Access Compliance Report

Public Rights-of-Way

(Curb Ramps)

Intersection ID: 9530	Main Street: MCBRIDE_ST	Cross Street: THE_PLAZA	Location: SE
ADA ID: 52CD69EE4795	Ramp Type: PerpDiag	Initial Pass/Fail: Fail	Overall Compliance: No
Codes/Mitigation Info/Possible Solution		Field Measurements/Component Compliance	
Severity Score: 13.75

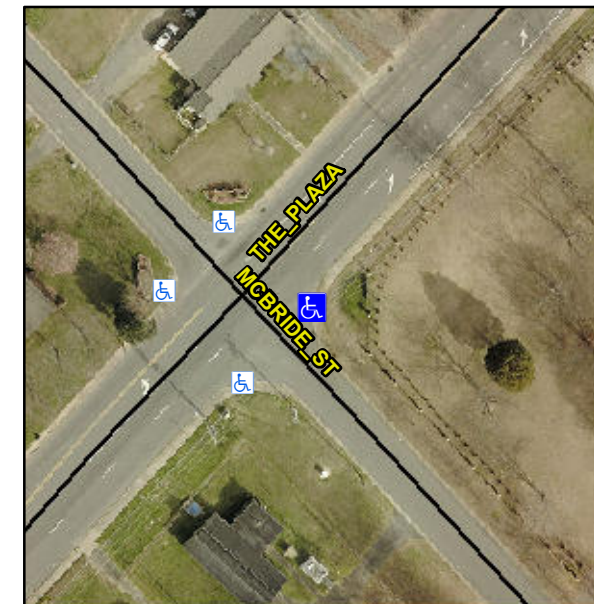
Not Found, R304.2.2, R304.5.3

Compliance	Description	Data	Compliance	Description	Data
N/A	Ramp Length (in)	60.0	No	Ramp Slope (%)	9.1
Yes	Ramp Width (in)	54.0	No	Ramp XSlope (%)	2.7
N/A	Flare Type LT	N/A	N/A	Flare Type RT	N/A
N/A	Flare Slope LT (%)	N/A	N/A	Flare Slope RT (%)	N/A
N/A	Flare Traversable LT?	N/A	N/A	Flare Traversable RT?	N/A
N/A	Landing Length (in)	N/A	N/A	DWS Provided?	N/A
N/A	Landing Width (in)	N/A	N/A	DWS Contrast?	N/A
N/A	Landing Slope (%)	N/A	N/A	DWS Length (in)	N/A
N/A	Landing X Slope (%)	N/A	N/A	DWS Full Width?	N/A
N/A	Landing Curb? (Y/N)	N/A	N/A	DWS Offset (in)	N/A
N/A	Shared Landing?	N/A			
N/A	Gutter Ponding?	N/A	N/A	Gutter Slope (%)	N/A
N/A	Gutter Lip Ht (in)	N/A	N/A	Gutter X Slope (%)	N/A
N/A	Painted X Walk1?	No	N/A	Painted X Walk2?	No
	X Walk 1 Direction	To NW		X Walk 2 Direction	To SW
N/A	X Walk 1 Width (in)	N/A	N/A	X Walk 2 Width (in)	N/A
	X Walk 1 Slope (%)	2.7		X Walk 2 Slope (%)	0.3
	X Walk 1 X Slope (%)	1.2		X Walk 2 X Slope (%)	1.9

Remove & Replace Curb Ramp With Two New Directional Ramps or Equivalent.
